44474A-01**S E R V I C E N O T E**Supersedes:
NONE**44470A** 10 channel multiplexer module for 3499A/B. Includes a screw terminal block**44471A** 10-channel General Purpose Relay for 3499A/B. Includes a screw terminal block**44473A** 4x4 Matrix Module for 3499A/B. Includes a screw terminal block**44474A** 16-bit Digital I/O Module for 3499A/B. Includes a screw terminal block**Serial Numbers:**

Defective connectors shipped with 44470A, 44471A, 44473A, 44474A

Figure 3: Defective Connector with all pins on one side

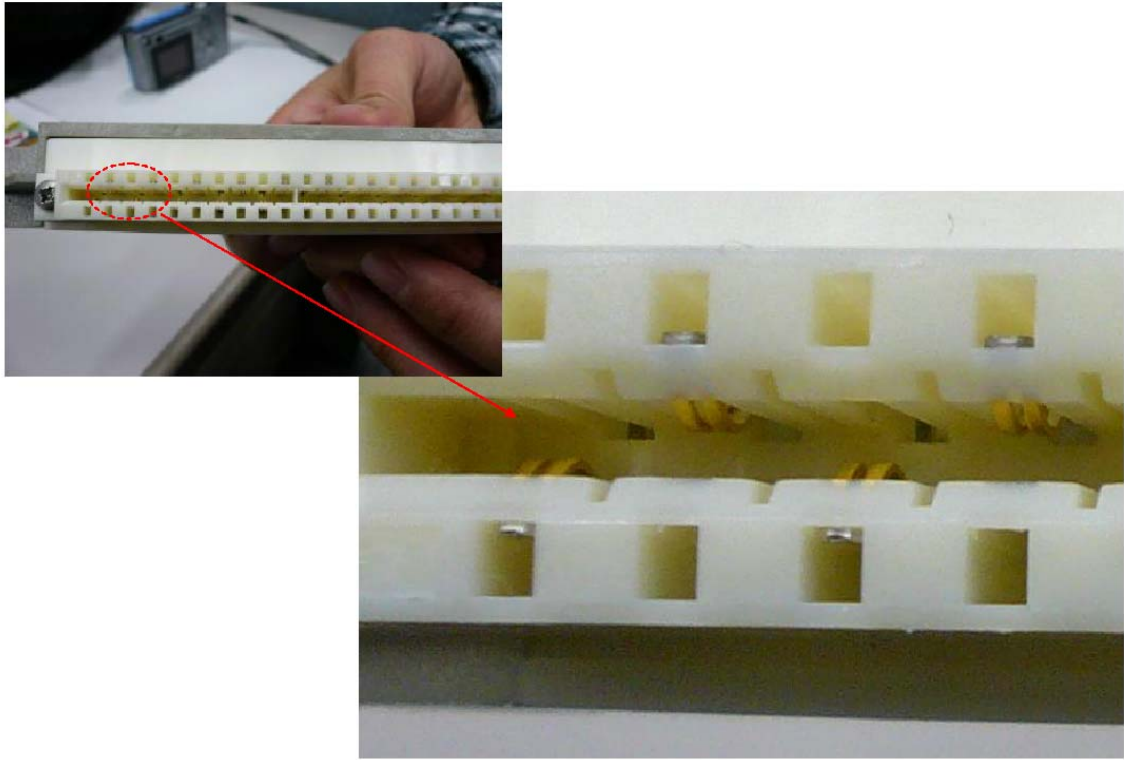
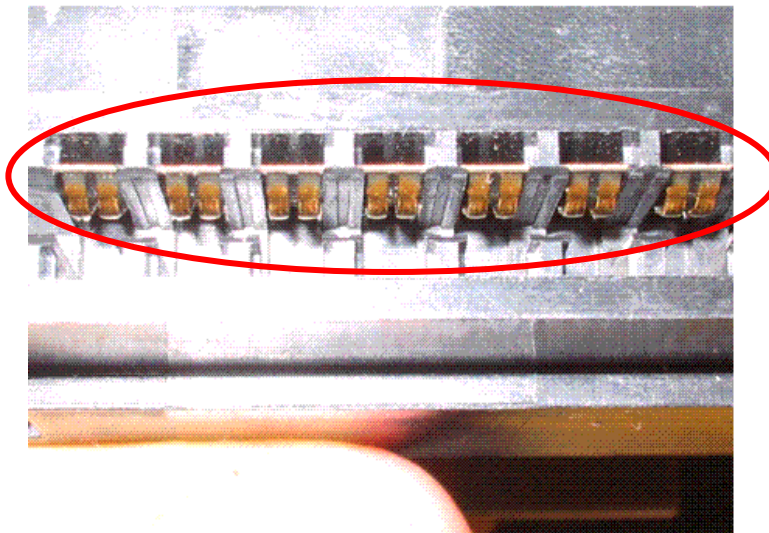
The 44470A, 44471A, 44473A, and 44474A contain a main relay card and a removable screw terminal block (see Figure 1). Some of the removable terminal blocks that were shipped between 1-Jan-2008 and 08-April-2008 have a defective connector that results in half of the pins being unconnected.

The 44470A, 44471A, 44473A, and 44474A products consist of a main relay plug in module and a removable terminal block (see Figure 1). These are plug in modules for the card cage mainframes 3488A, 3499A, 3499B, and 3499C. The main relay card contains the serial number. The removable terminal module does not contain a serial number. A visual inspection of the connector in the removable terminal block is necessary to determine if a defective connector is present. All white colored connectors are good and have pins that alternate top to bottom (see Figure 2). A black colored connector is bad if it contains all pins on one side of the connector (see Figure 3). A black colored connector is good if it contain pins that alternate top to bottom (not pictured).

The procedure to correct the defective connectors is very simple. One must replace the defective connector with a good connector (see connector part numbers list on page 2). The customer may perform this procedure or have an Agilent-qualified person perform this procedure.

Figure 4: Removing defective connector from terminal block

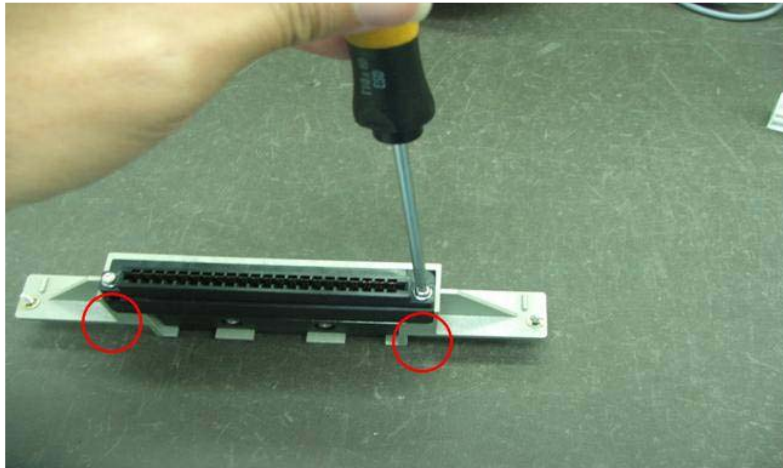
Connector Replacement Procedure: After identifying a defective connector, the connector in the terminal block is repaired by removing the two screws that hold the connector to its case. Note the orientation of the connector. This will release the connector from the terminal block and then a good one can replace it. No soldering is necessary. See Figure 4.

1. Use a T10 torx driver to unscrew the 2 screws of the connector.

Use the same torx driver to screw on the good connector, using the same orientation at the connector you just removed (see Figure 5).
